# Safety Evaluation Report (Revised) for the Dewey-Burdock Project Fall River and Custer Counties, South Dakota

## Materials License No. SUA-1600

Docket No. 40-9075  
Powertech (USA) Inc.

**U.S. Nuclear Regulatory Commission**

Figure 1. Comparison of the Reported Drawdown and Drawdown from the modeling Software

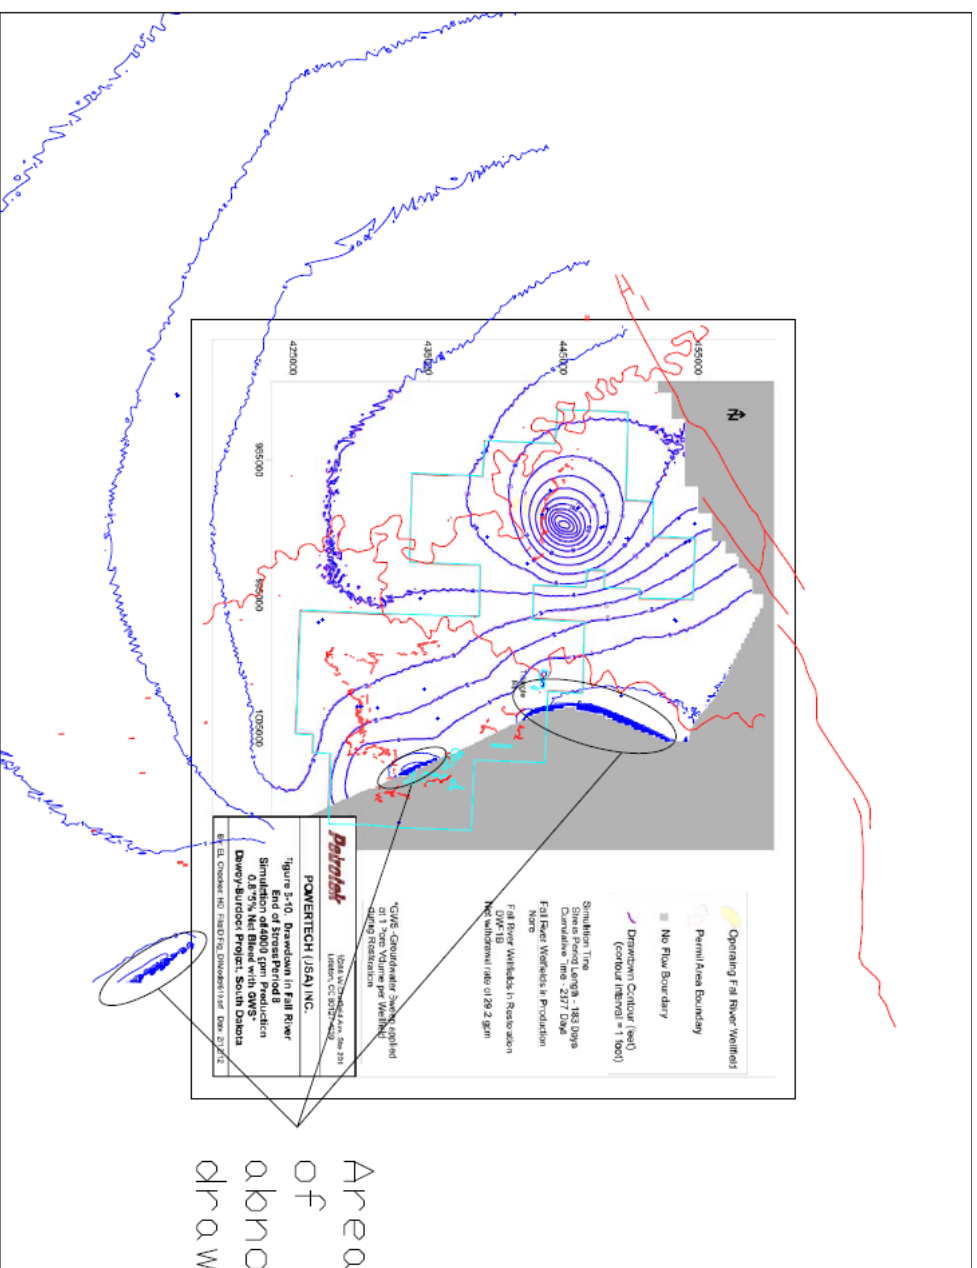
Staff reviewed the model geometry, hydraulic properties and parameters and locations of the boundaries. Several minor discrepancies were noted between the electronic files and the report (Table 1). In general, the discrepancies represent minor errors and are common for complex models. Most of the discrepancies would not appreciably impact the model predictions; however, staff was concerned about the abnormal drawdown adjacent to the GHB conditions (Figure 1). The abnormal drawdown may be attributed to discrepancies noted in the recharge, storativity or GHBs (see Table 1), or, conflicts with the starting head file.<sup>1</sup>

Staff corrected the model for discrepancies in recharge, storativity and GHBs, and established starting heads for the predictive simulation using the output from the steady-state calibration simulation. Correcting the model affected the predicted drawdowns in the Fall River Formation and Chilson Member, as shown in Figure 2 and Figure 3, respectively. The effect of the corrected model on the Fall River Formation model-predicted drawdown is to increase the drawdown by approximately 1 foot. The effect on the Chilson Member model-predicted drawdown is less than that for the Fall River Formation.
